# City of Richmond

## Report to Development Permit Panel

**File:** DP 14-657872

**Re:** Application by Yamamoto Architecture Inc. for a Development Permit at 9055 Dayton Avenue (Formerly 9051 and 9055 Dayton Avenue)

DATE: 14.06.06  
SCALE: 1/4"=1'-0"  
JOBS NO: 11-238  
SHEET NO: 1 OF 1

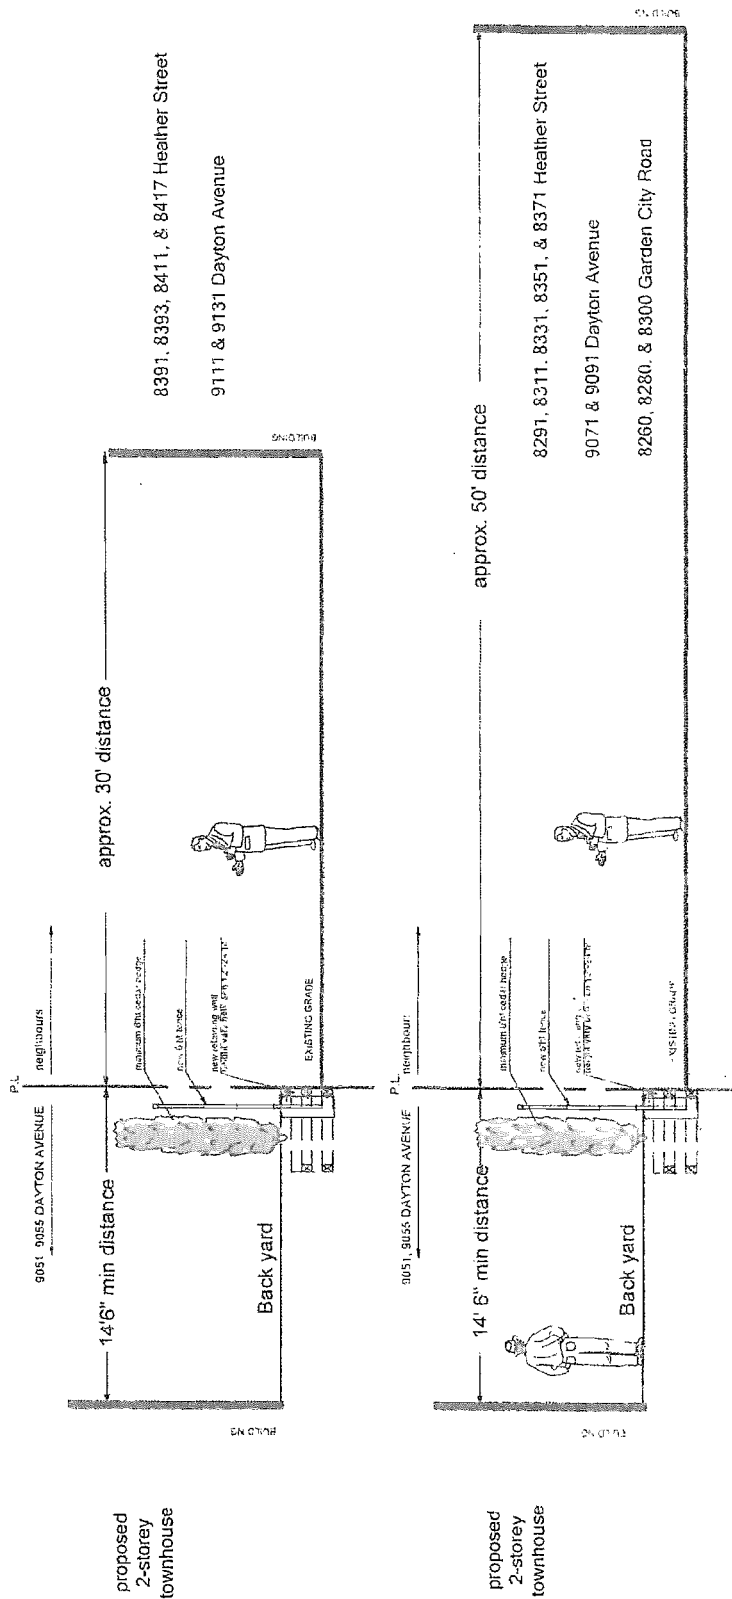
I have attached the letter that was sent to all the Dayton Avenue neighbours, and the neighbours have asked me to represent them in inquiring on our choices in this matter. By looking at the Section Sheet SK1, the proposed new retaining wall is comprised of railway ties, and the neighbours are concerned about possible water runoff into their property since the townhouse complex is elevated higher. A solid concrete foundation could be a better solution, but that is a choice of the geotechnical engineer and financial economics. The neighbours are also concerned of the initial spacing of the proposed new tree hedging. The neighbours would prefer if they had no choice of keeping the original trees, that the new hedges be a completed privacy barrier, not one that will take the next ten years to mature into a privacy barrier.

Lastly, you will notice from the cross section illustration prepared by our Landscape Architect, we are now proposing a chain link fence instead of a wooden fence. This change is due to the feedback of the neighbourhood and that some neighbours would prefer to see only hedges. The chain link fence would allow the hedges to grow in between the links and over time only the hedge would be visible. A chain link fence is also expected to both last longer and require less maintenance than a wooden fence. However,

**FENCE PLAN**

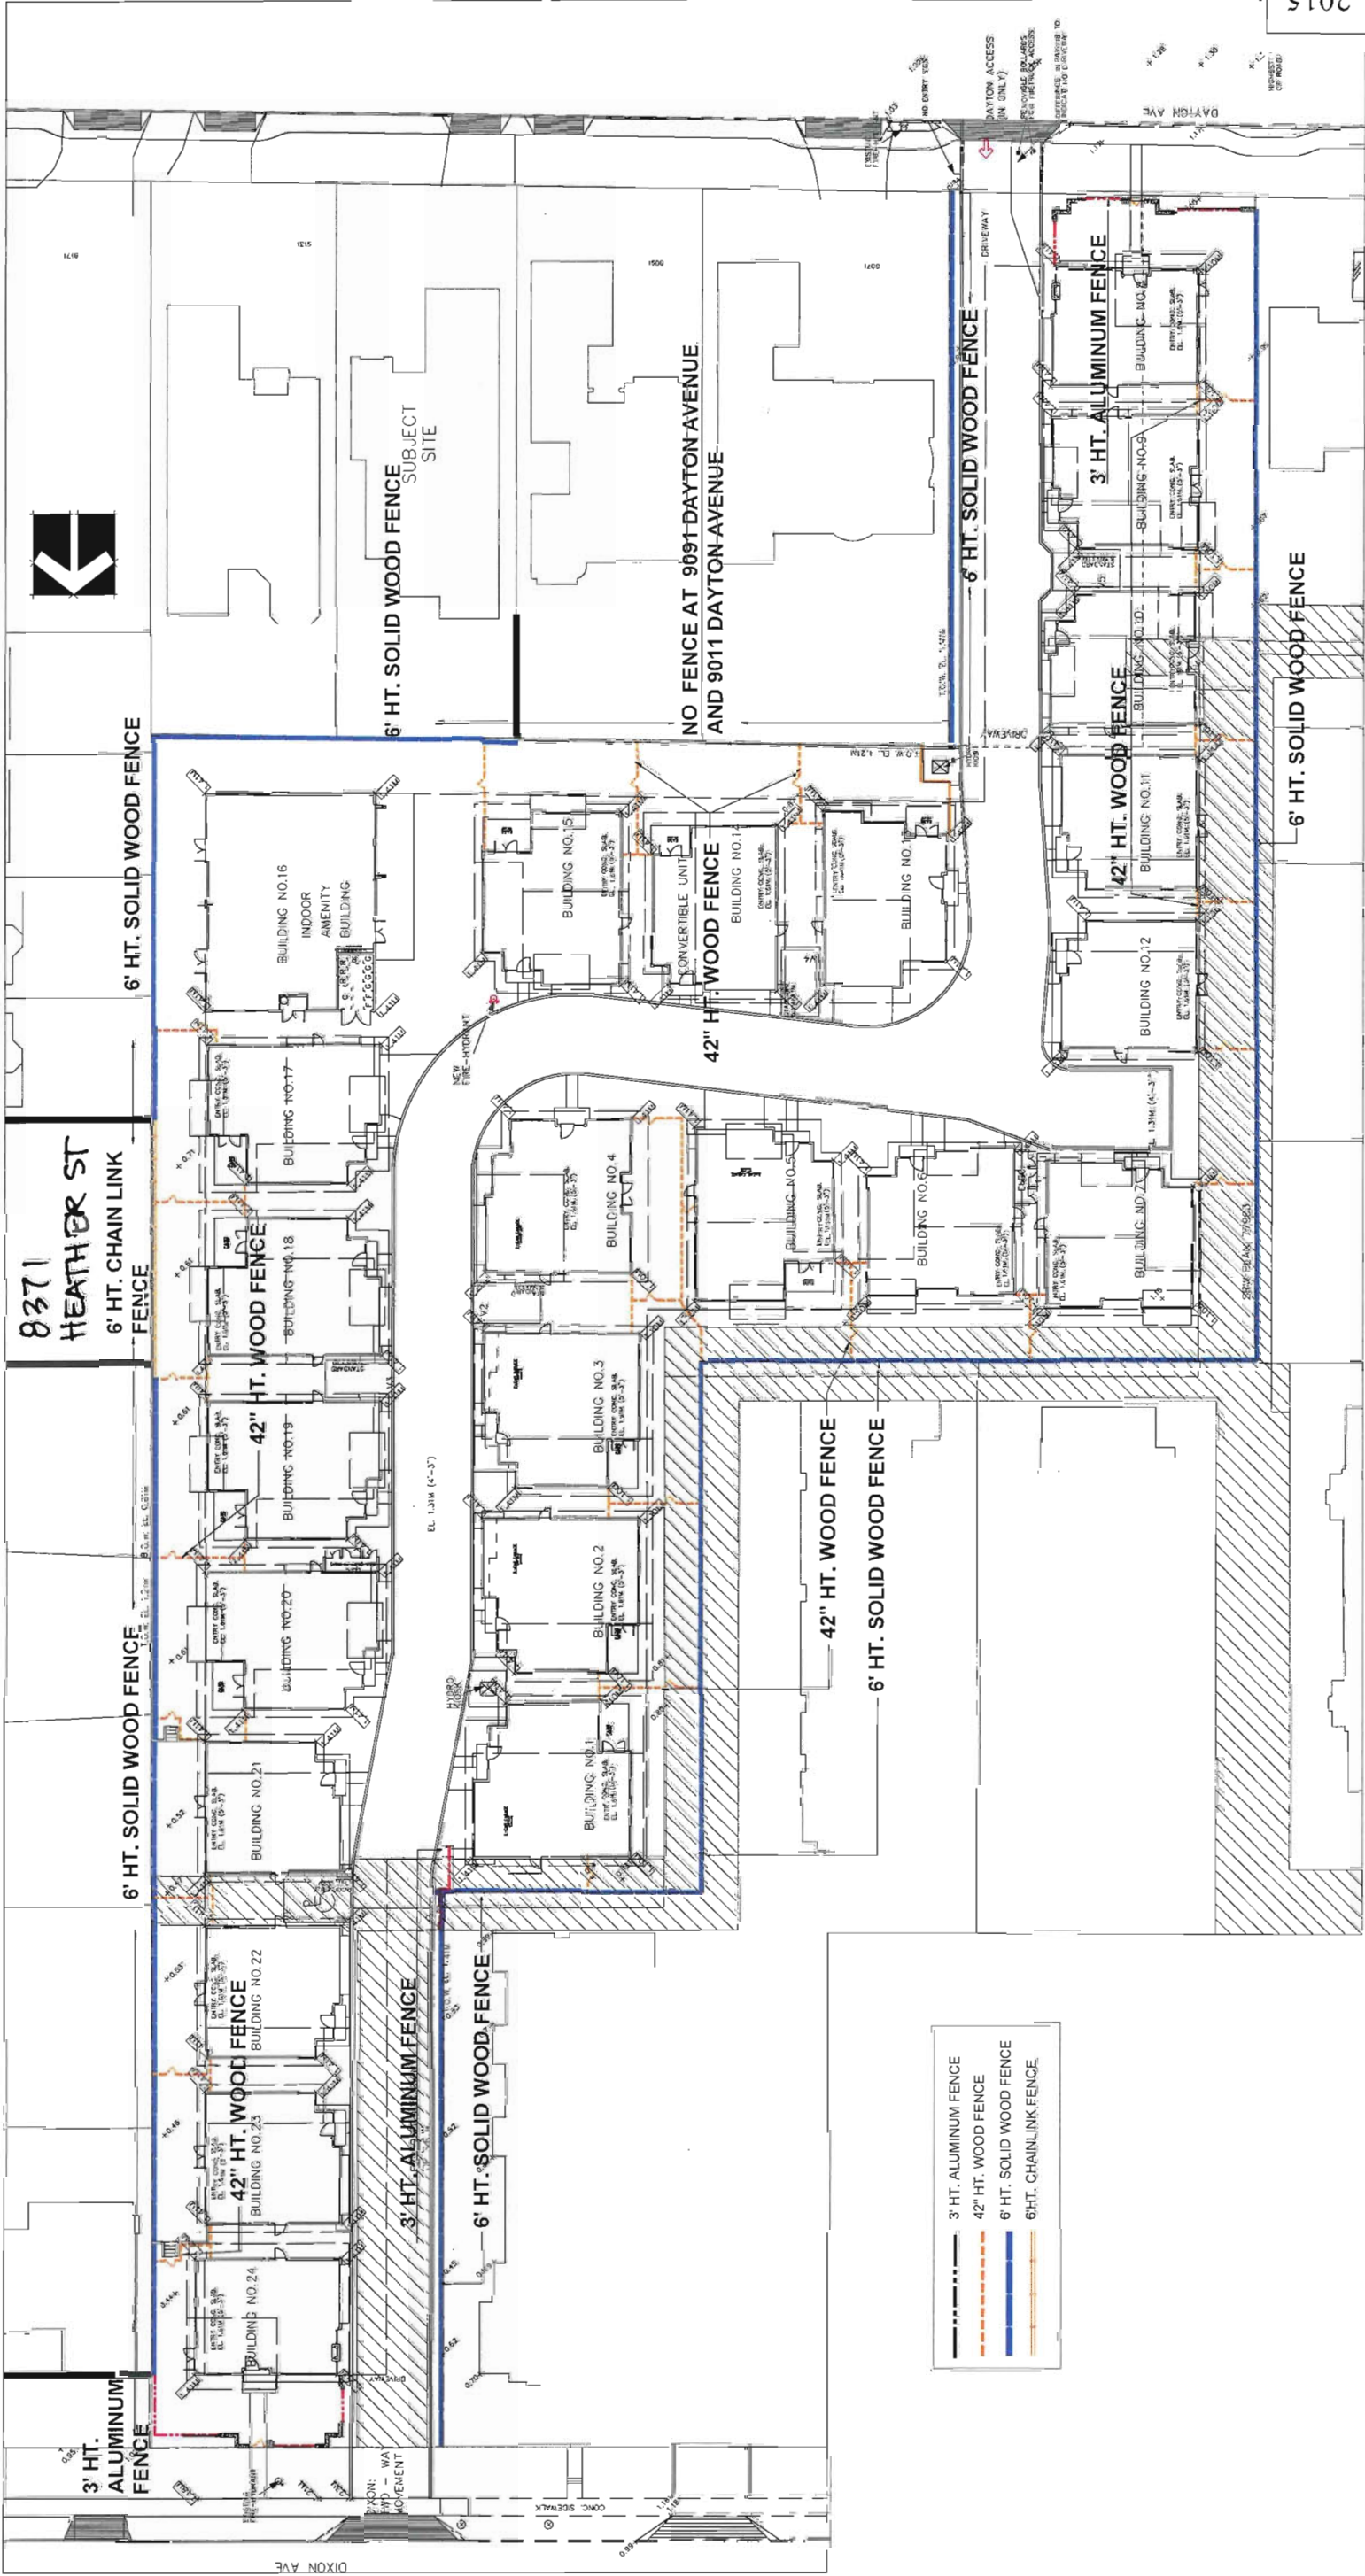
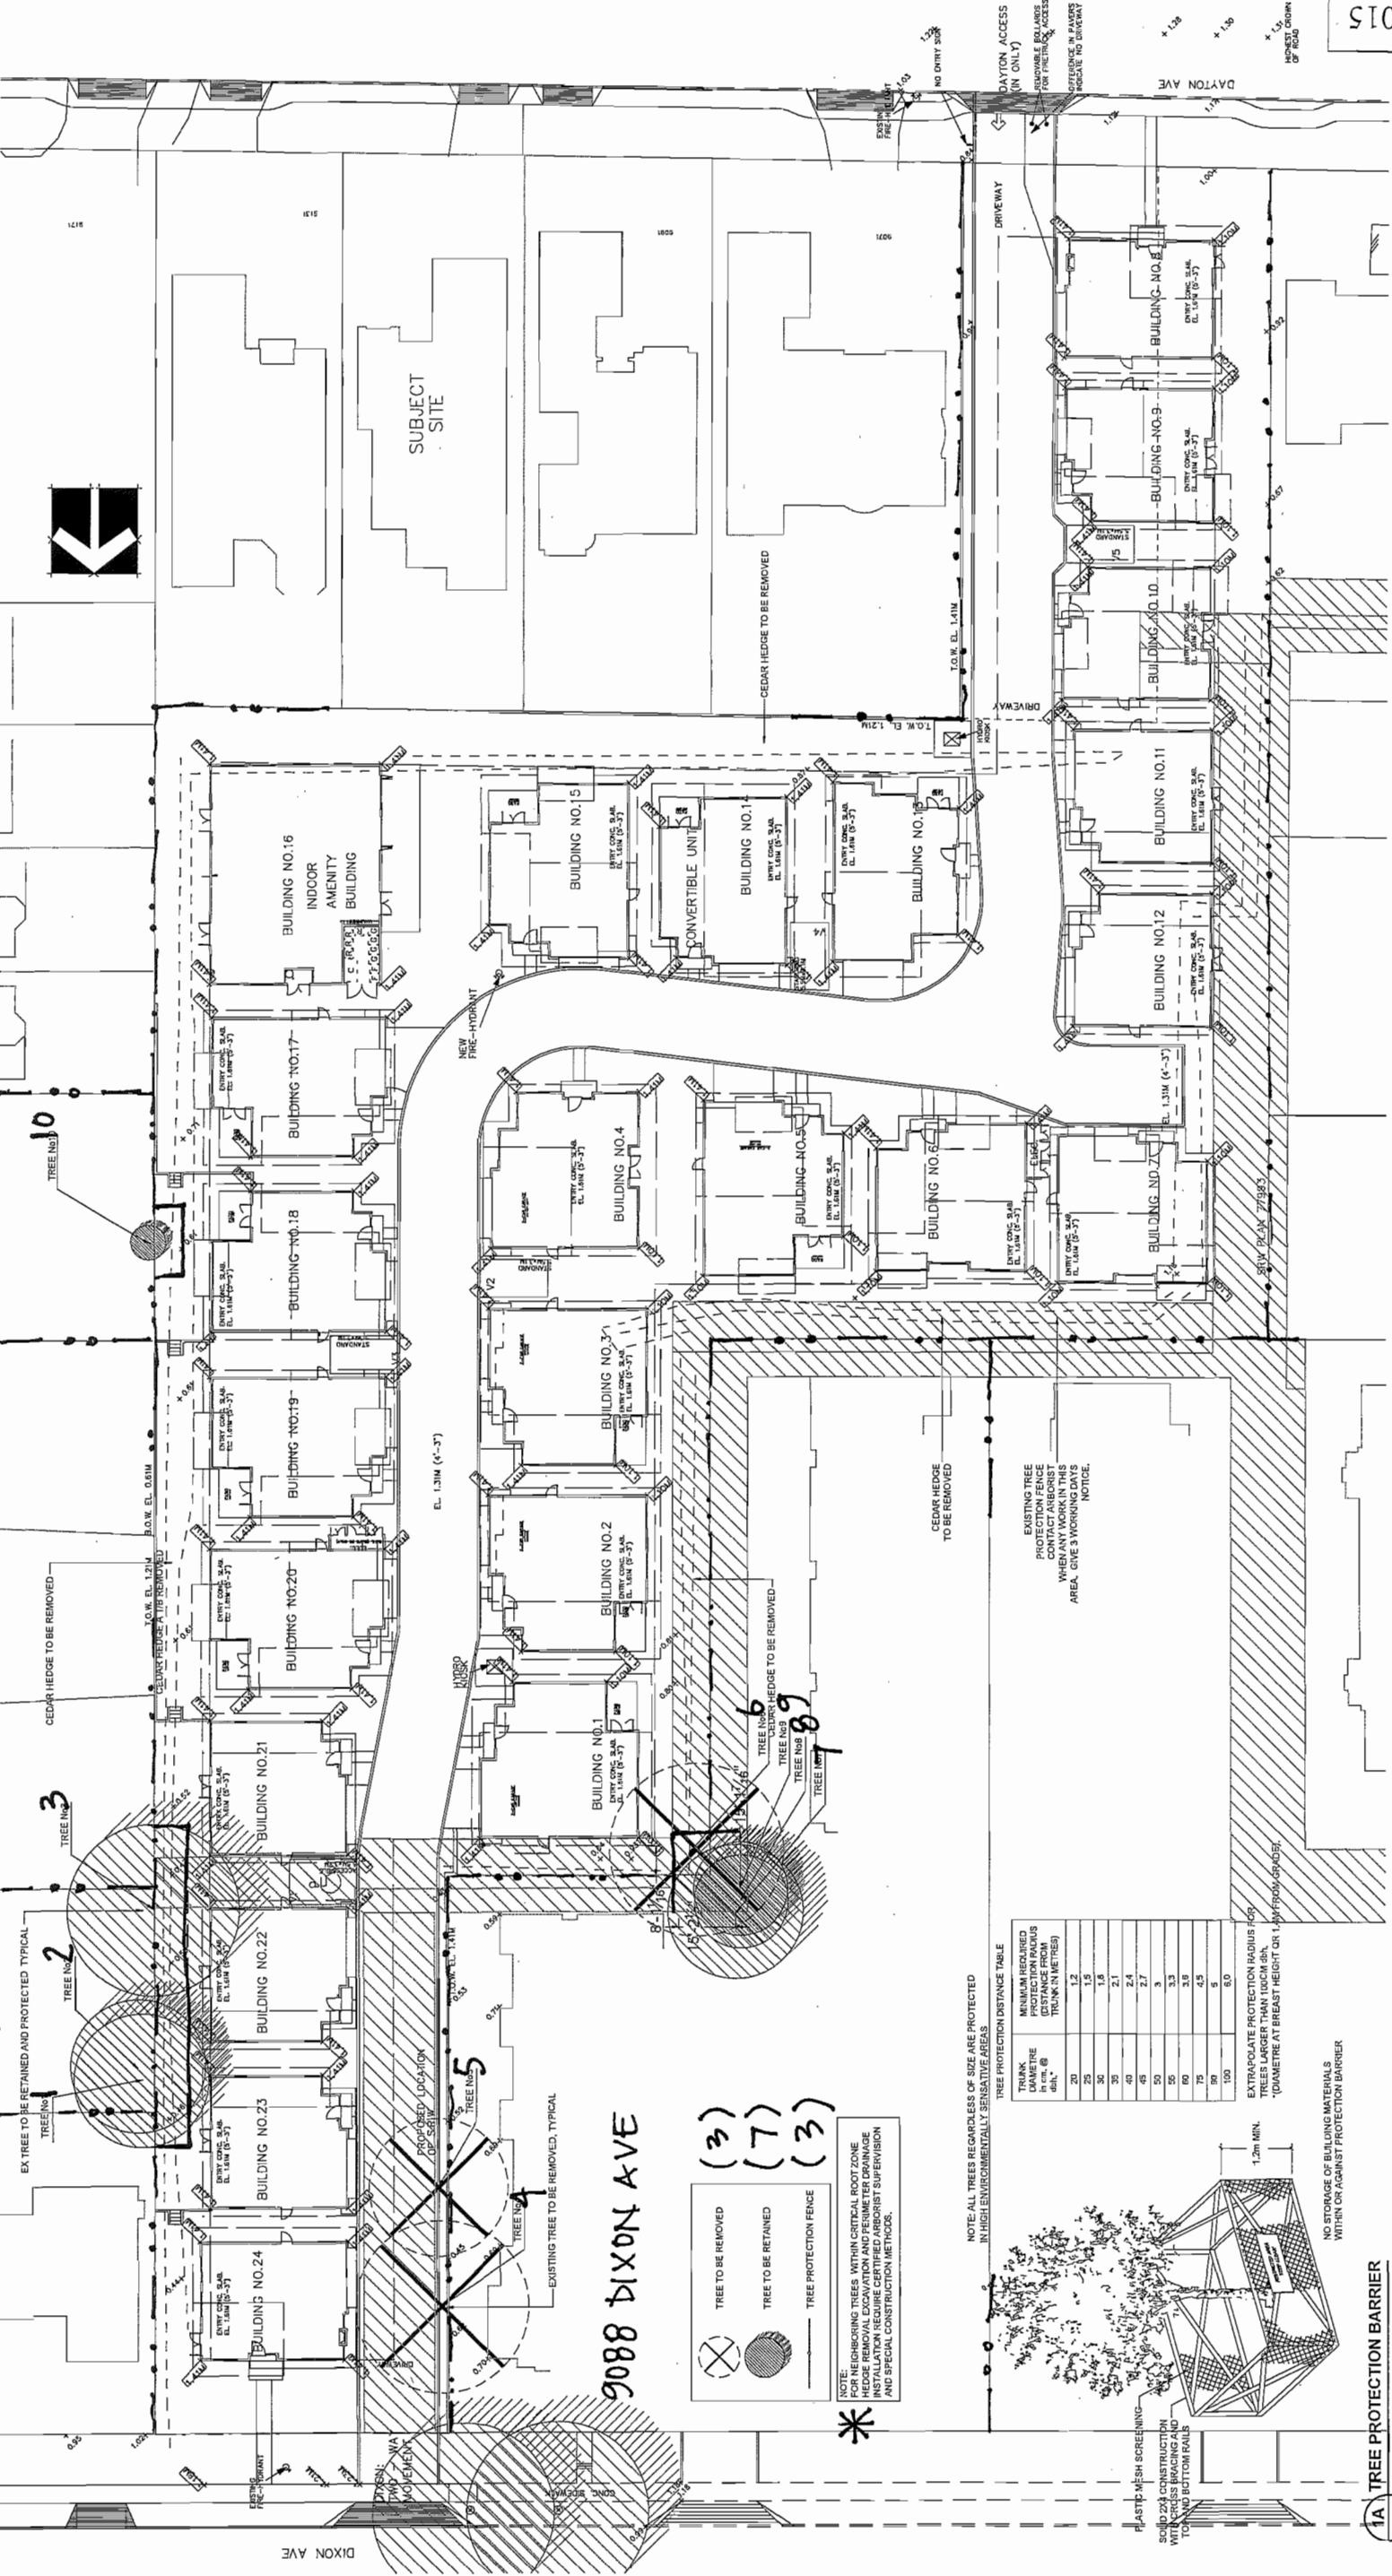
In response the Development Permit Panel's referral to examine the proposal to install fencing along the property line, the applicant has revised the landscape plan to identify 1.8 m height solid wood privacy fencing along all shared property lines, except for small areas where black plastic coated chain link fencing and no fencing will be provided as requested by the three (3) adjacent land owners.

In response to the referral, discussion at Development Permit Panel, discussions with neighbours and working with staff, the applicant has revised the landscape proposal to increase the height of proposed replacement perimeter hedging from 2.4 m to a minimum of 3 m, which will ultimately provide an effective screen to adjacent properties. The landscape proposal was also revised to provide areas with 1.8 m height wood perimeter fencing, areas with no perimeter fencing and areas with black plastic coated chain link fencing as requested by neighbours of the development site.
